RECALL SERVICE BULLETIN

DATE ISSUED	MODEL YEAR(S) AFFECTED	RSB #
12/15/2016	2017	473

Newmar Corporation has decided that a defect relating to motor vehicle safety exists in specific 2017 King Aire motorhomes. NHTSA # 16v 848

How to Replace the Accent Light Module

Inspecting the New Module

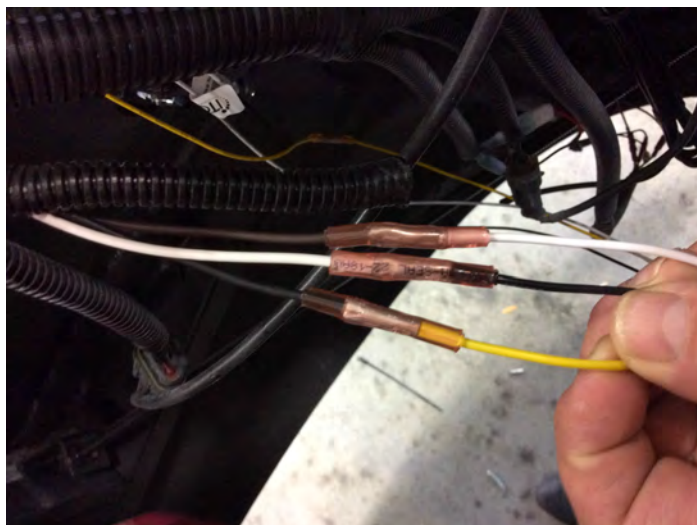
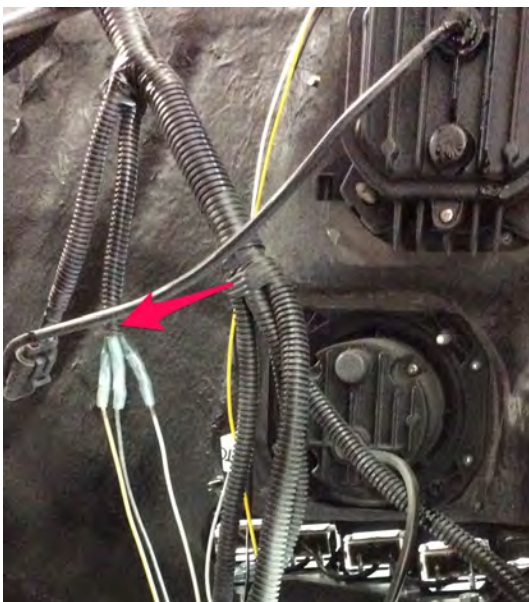
The new sealed light module will have stripped wire leads on one side, which will connect to the coach wiring. The other side will have connectors on them. It is important to correctly install the module due to a diode that was added.

1. Locate the three wires connecting the accent light to the light module.
2. Cut the connection from the light module, and strip the three wires back.
3. On the new module, find the side with terminals. This will hook up to the light, so do not reverse them.
